Community Alternative to Current

St. Vincent's/Rudin Plan

Community Alternative to Current St. Vincent's/ Rudin Development Plan

January, 2008

Possible Scheme Under Community Alternative Plan

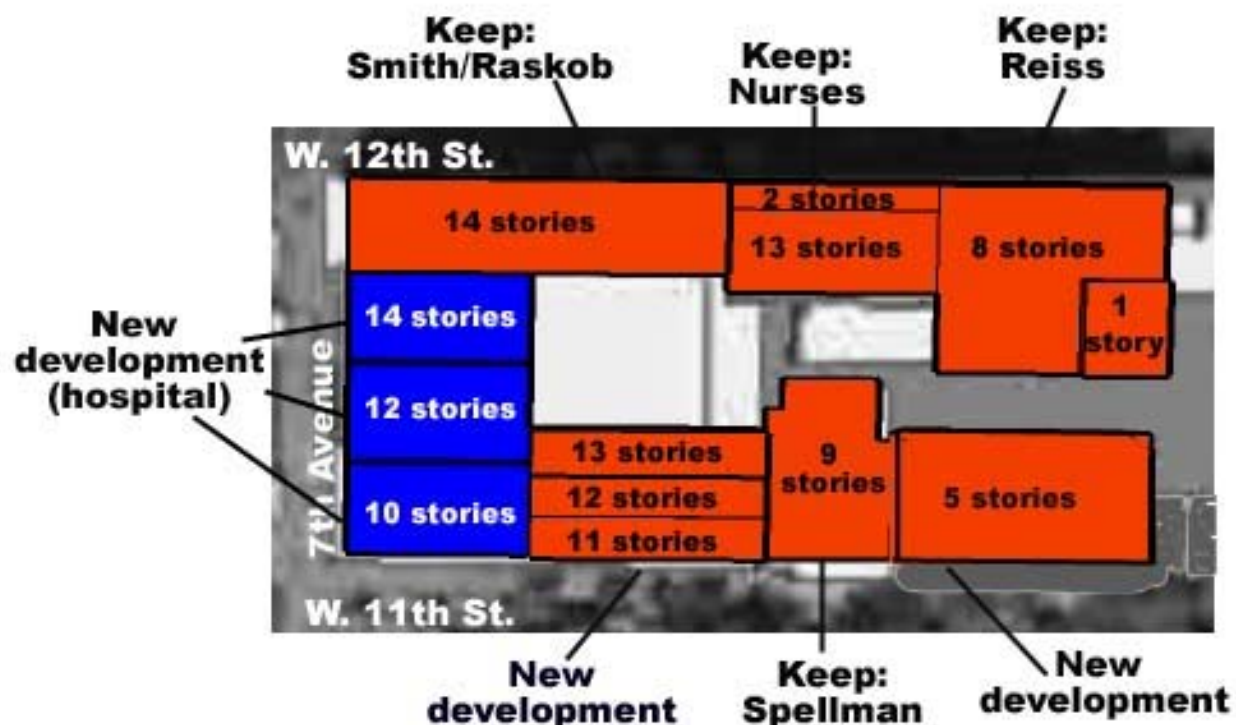
- **Keep new hospital building on O'Toole site to no larger than surrounding buildings** – 190 feet – by developing a second hospital building on the east side of 7th Avenue (presumably on Coleman/Link site); two new hospital buildings can be connected using current underground tunnel

625,000 sq. ft. (approx.) above ground

View East - Proposed

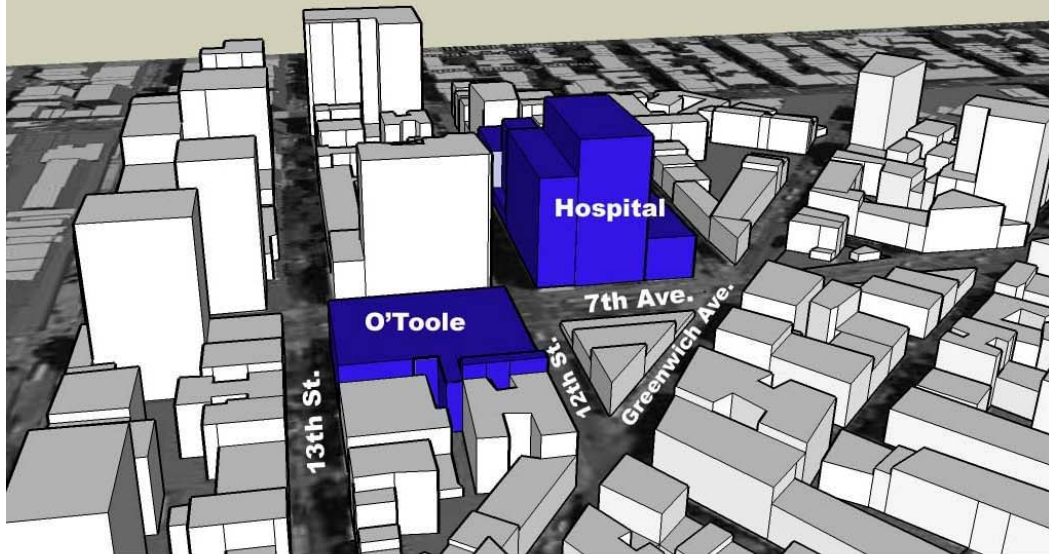
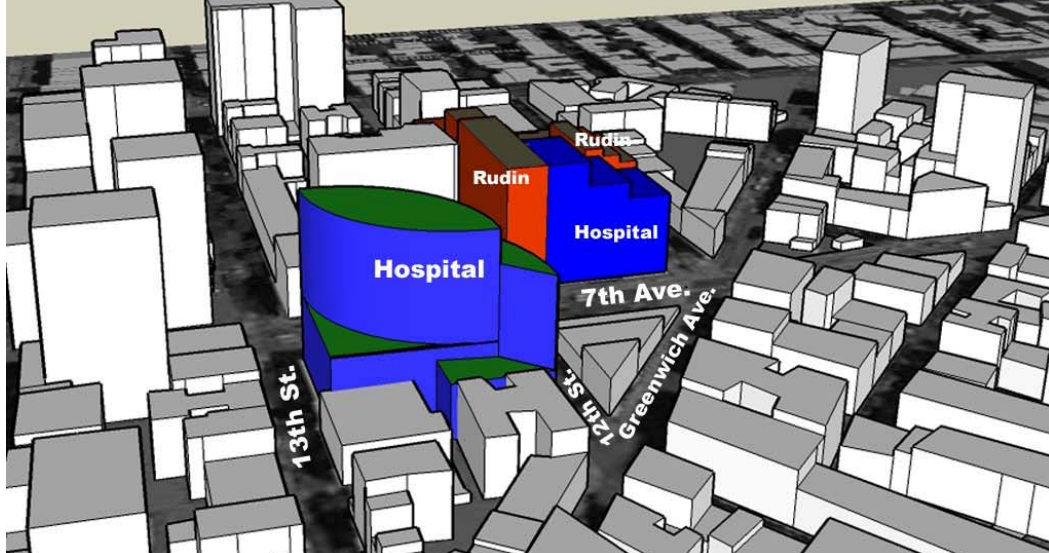
- Rudin 7th Avenue building is too large and out-of-scale for neighborhood and historic district
- Hospital building is too large and out-of-scale for neighborhood and historic district

- **Reduce the height of the new hospital on the O'Toole site to no more than the tallest surrounding buildings** (approx. 190 ft. as opposed to current planned 329), **while maintaining the current design and configuration of the ovoid tower and remaining within the current planned envelope for the proposed building** (i.e. reducing its size and height, rather than changing the distribution of mass). Facilities removed from the hospital building currently planned for the O'Toole site could be located on the east side of 7th Avenue, on the current St. Vincent's campus
